**Subject: Zoning By-law Amendment – 212 and 214 Donald Street**

**File Number: ACS2022-PIE-PS-0111**

**Report to Planning Committee on 25 August 2022**

## Document 4 – Comments from the Overbrook Community Association

**Rear Yard parking**

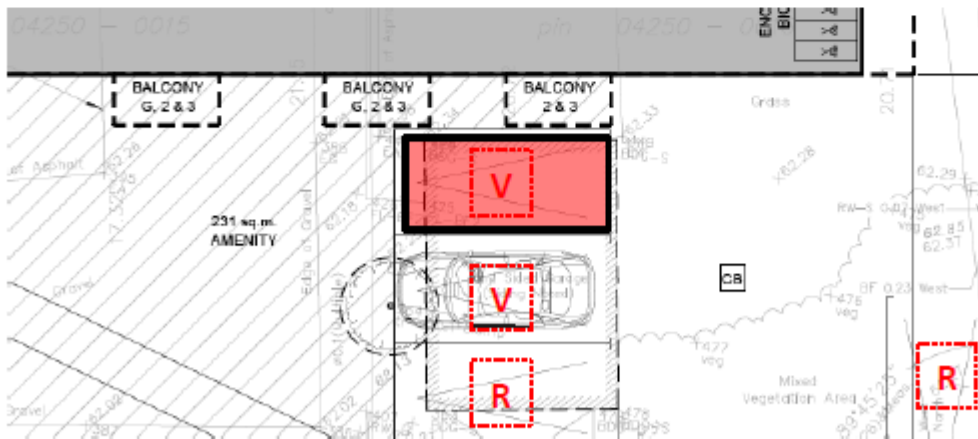
The below illustrations show how a rear yard parking space is very close, about 1.5m, from the windows in the lower basement level. We do not know if those windows are of a rental unit or a laundry room or bicycle storage area. If those windows are a tenant unit it is not very pleasant to look at cars parked only 1.5m from your window. Require as a condition of site plan approval that those two nearest parking spaces be for visitors, which might be empty at times, and have the two required parking spaces for the tenant residents be the two spaces furthest away (at the south of the lot).
